# Access Compliance Report

## Public Rights-of-Way

| Intersection ID: 31610                  | Main Street: WINDY_VALLEY_DR | Cross Street: GUSTY_CT                  | Location:              | S                  |
| ADA ID: ABFA324D0924                    | Ramp Type: PerpDiag          | Initial Pass/Fail: Pass                 | Overall Compliance: No | Severity Score: 10 |

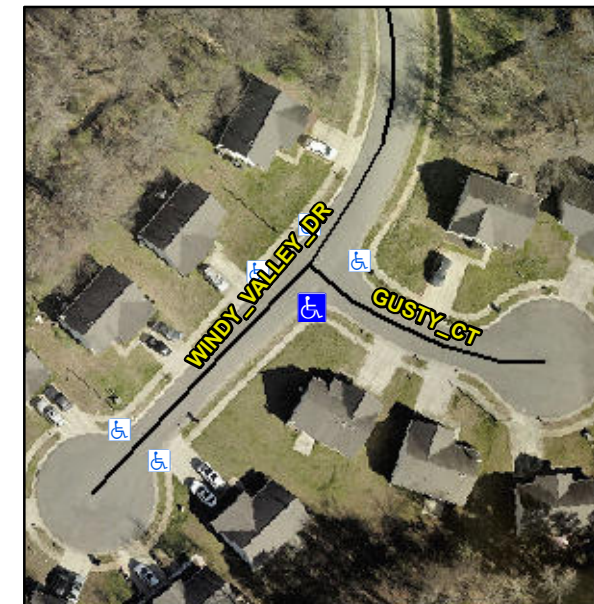
**Not Found, R304.2.2-Perp, R304.3.2-Para, R305.1.4, R305.2, R302.7.2**

| Compliance | Description           | Data   | Compliance | Description                 | Data  |
|------------|-----------------------|--------|------------|-----------------------------|-------|
| No         | Landing Slope (%)     | 4.1    | Yes        | DWS Length (in)             | 24.0  |
| Yes        | Landing X Slope (%)   | 1.1    | No         | DWS Full Width?             | No    |
| N/A        | Landing Curb? (Y/N)   | No     | No         | DWS Offset (in)             | 3.0   |
| No         | Gutter Lip Ht (in)    | 0.5    | Yes        | Gutter X Slope (%)          | 0.4   |

**Remove & Replace Curb Ramp With Two New Directional Ramps or Equivalent.**
